**NOTICE OF DECISION TO CONSENT TO CHANGE TO PROPOSAL DURING
ASSESSMENT**

Greater Paraburdoo Iron Ore Hub
Assessment No. 2189

STATEMENT OF REASONS

Proposal: Greater Paraburdoo Iron Ore Hub

Figure 1: Changed conceptual footprint

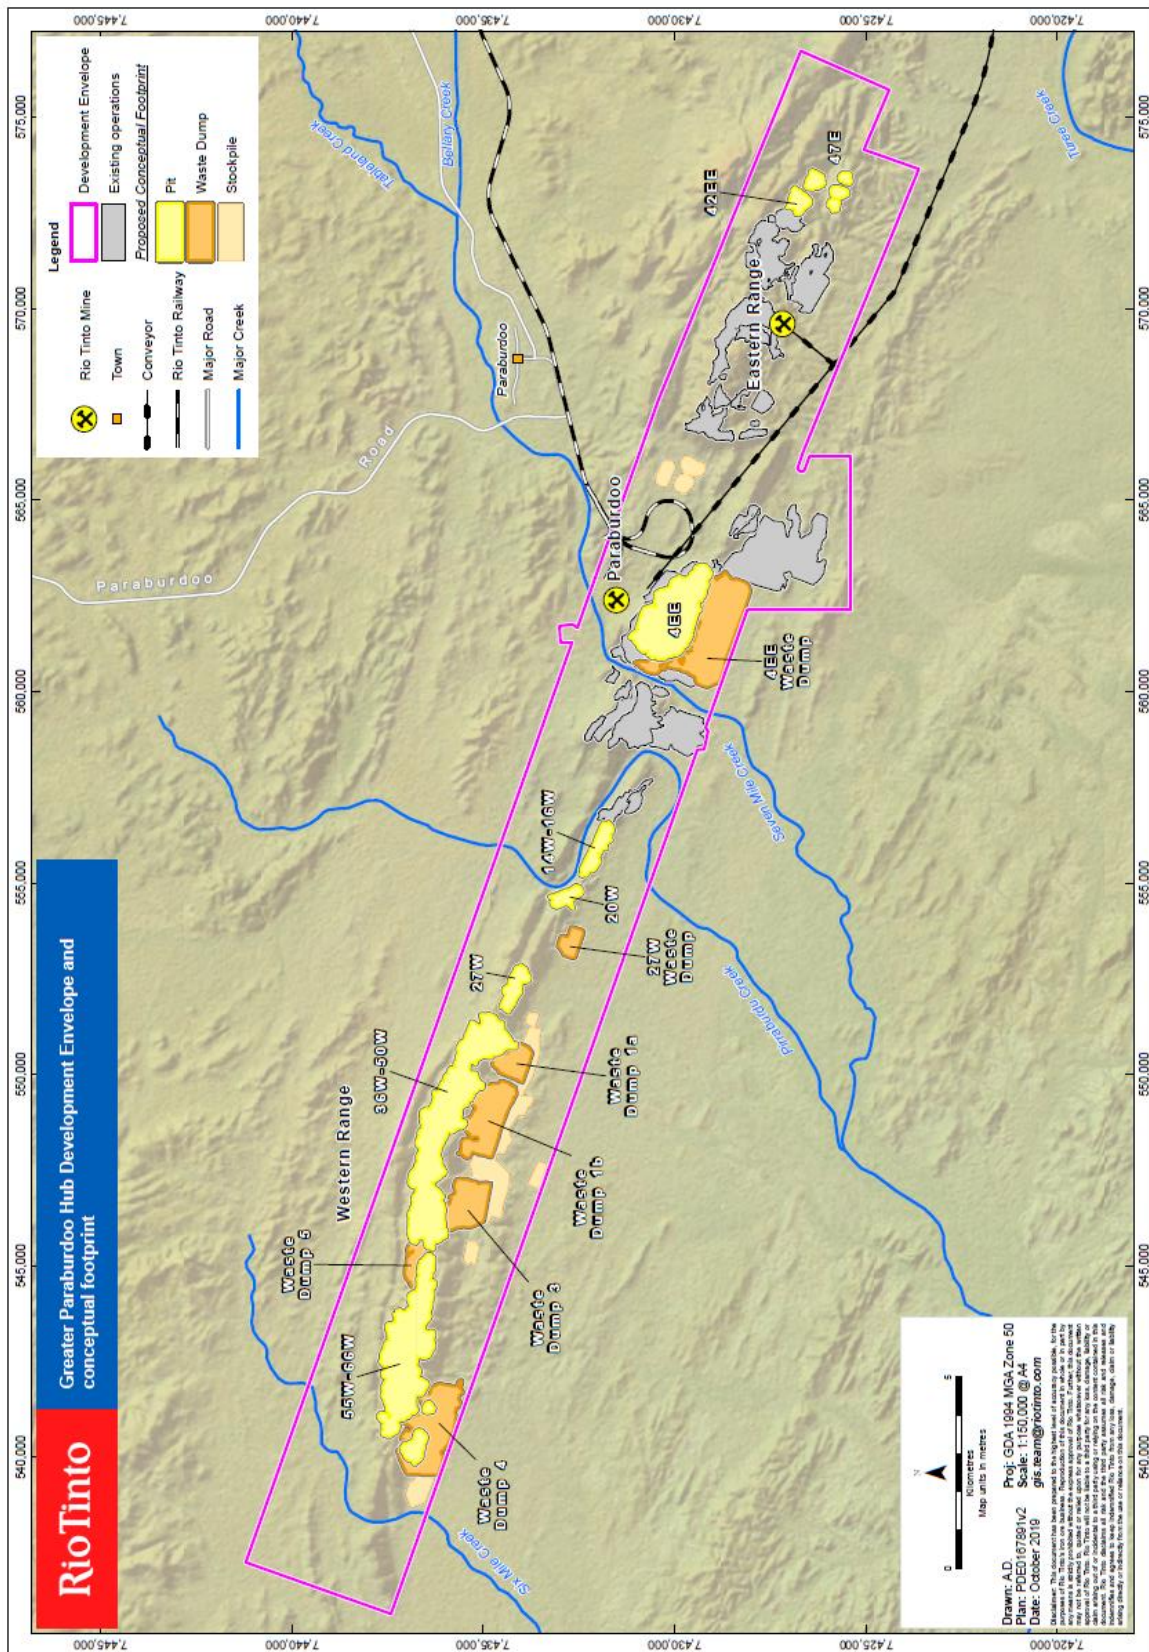
- A reduction in the amount of surplus water to be managed (reduced from 6 gegalitres per annum (GL/a) to 1.7 GL/a).
- Removal of the option to manage surplus water via aquifer reinjection.
- Changes to the conceptual footprint design to include low-grade ore stockpiles at Eastern Range with no net increase to clearing area.
- Correction of authorised clearing areas from 220 hectares (ha) to 251.4 ha to correctly reflect existing approved clearing permits in the table of key characteristics of the proposal.
- Change the operational element 'dewatering' in the table of key characteristics of the proposal to 'dewatering and water supply'.

Table 1 presents the changes to the proposal. Figure 1 presents the changed conceptual footprint.

Figure 1: Changed conceptual footprint

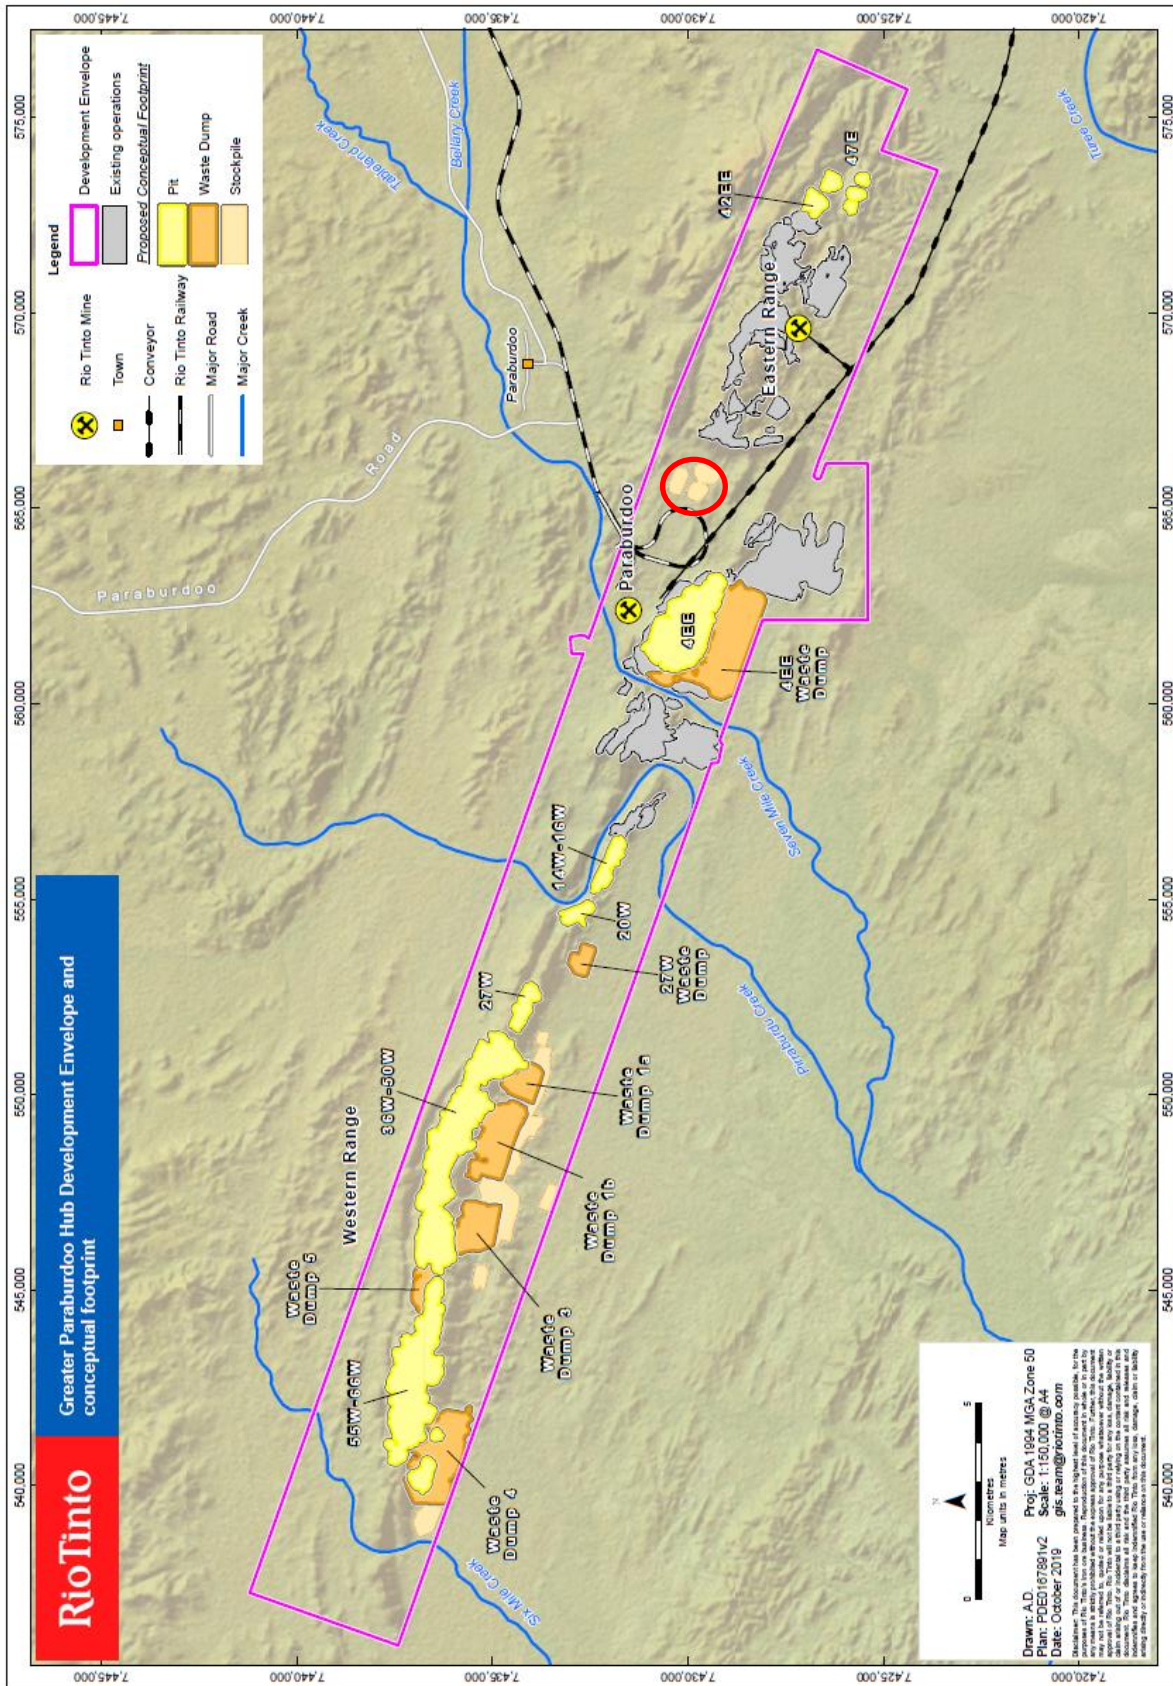
The addition of low-grade ore stockpiles at Eastern Range will not increase the overall disturbance for the proposal (4,300 ha). This change is to provide the proponent with the option to stockpile low-grade ore at this location, to be fed as required to the Paraburdoo processing plant.

The addition of low-grade ore stockpiles at Eastern Range does not increase the area of clearing that was referred for the proposal (4,300 ha). As such, the EPA considers that the change is unlikely to significantly increase any impact that the proposal may have on the environment.

Note: The red circle denotes the change to the conceptual footprint for additional stockpiles.
